**Briefing for PWSRCAC Board of Directors – May 2025**

**Project number and name or topic:** 6512 – Maintaining the Secondary Containment Liner

**Review of Electrical Leak Location and Electrical Resistivity  
Tomography Pilot Study of the Secondary Containment System at  
the Valdez Marine Terminal West Tank Farm Conducted July 2024**

22 January 2025

**Figure 4. Photographs (a) electrical leak location survey and (b) electrical resistivity tomography (from WSP 2024a)**

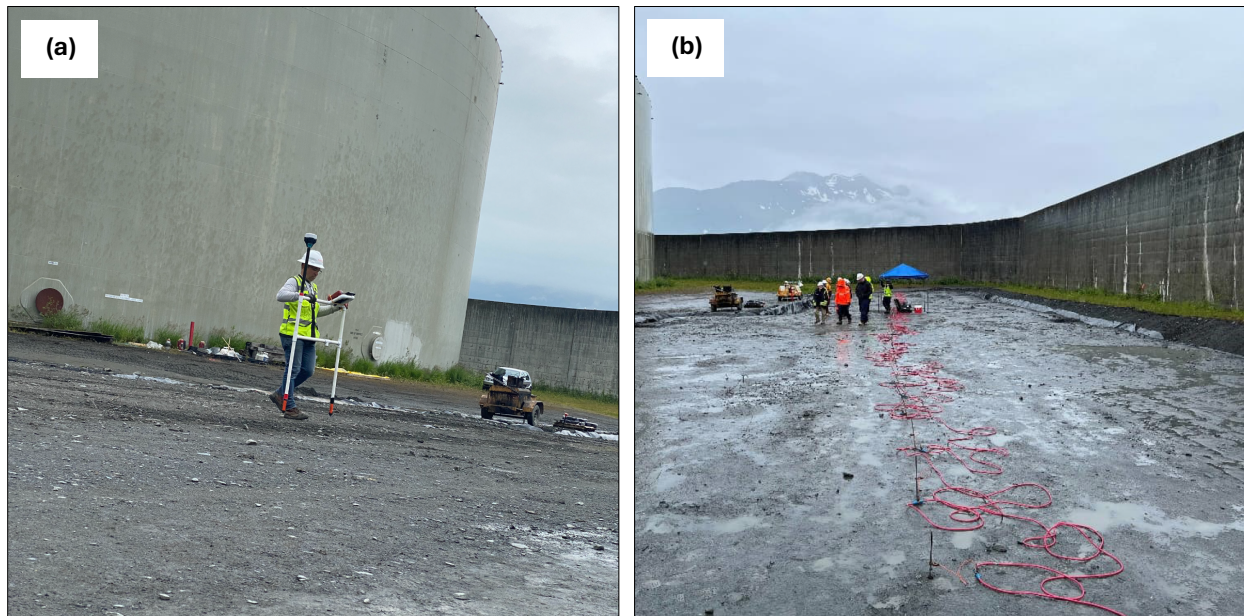
WSP notes that north-south survey transects were effective at locating the larger manufactured leaks, whereas none of the manufactured leaks were identified along the east-west survey transects. This dependence of transect orientation (north-south vs. east-west) is not common and is likely due to subsurface features that exist in the West Tank Farm, such as metal pipes, storm drains, and structural elements associated with the tank farm. These features may act as preferential flow paths for current below the liner, affecting orientation of the applied electrical field and masking electrical anomalies from defects in the CBA. Similar subsurface features are likely to exist in the East Tank Farm.

Furthermore, even though identified manufactured leaks were only detected using ELL surveys along north-south transects, the pilot study should not be interpreted to indicate that pre-existing leaks (non-manufactured) leaks do not exist along the east-west transects (or elsewhere). North-south ELL survey transects were only conducted over a limited area around the manufactured defects (less than 1/3 of the total area). Consequently, pre-existing leaks may exist but were not found detected along the north-south transects.

ERT surveys were only conducted in a north-south orientation and not in perpendicular orientations like the ELL surveys around the manufactured leaks. However, given the data were collected in the same orientation as ELL surveys that were successful in identifying the larger manufactured leaks, the likelihood of detecting leaks with additional perpendicular ERT transects is small. Therefore, we agree that ERT does not appear to be effective for delineating leaks in the CBA at the VMT.

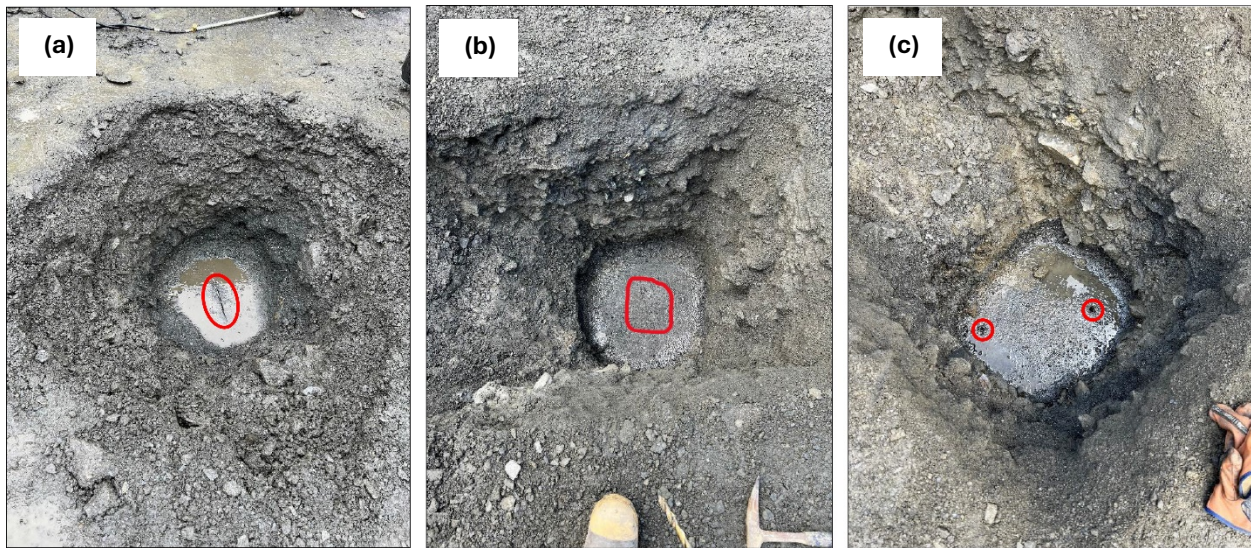
1. ***ELL can effectively locate larger leaks in the CBA.*** *East-west ELL survey transects did not detect any potential leaks but also did not detect any of the manufactured leaks. North-south ELL survey transects were effective at locating the larger manufactured leaks. Therefore, future ELL survey transects should be run both parallel and perpendicular to one another (e.g., both north-south and east-west).*

We agree that based on the findings of this study, ELL has been demonstrated to provide a method for indirect assessment of leaks in the SCS for the VMT East Tank Farm.
